Product Change Notification

Change Notification #: 117381 - 00
Change Title: Intel® Server Chassis R1304WTXXX,
PCN 117381-00,
Product Design, Order Code,
Rear panel and rear bracket new design
Date of Publication: January 09, 2020

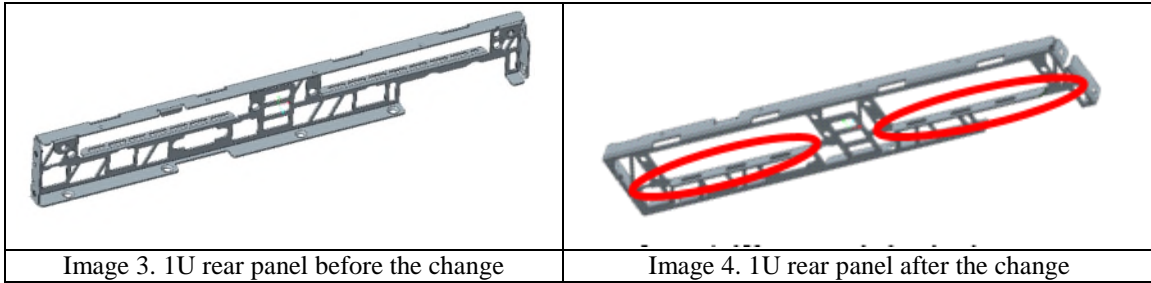
1. Change the design of the left rear bracket

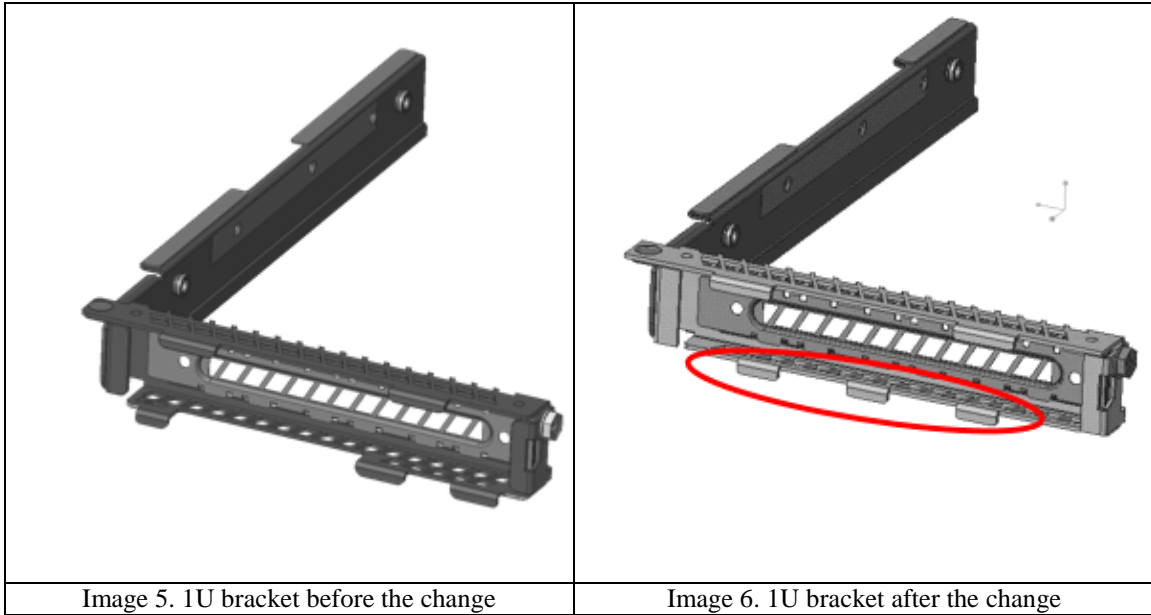
2. Adding holes to the rear panel
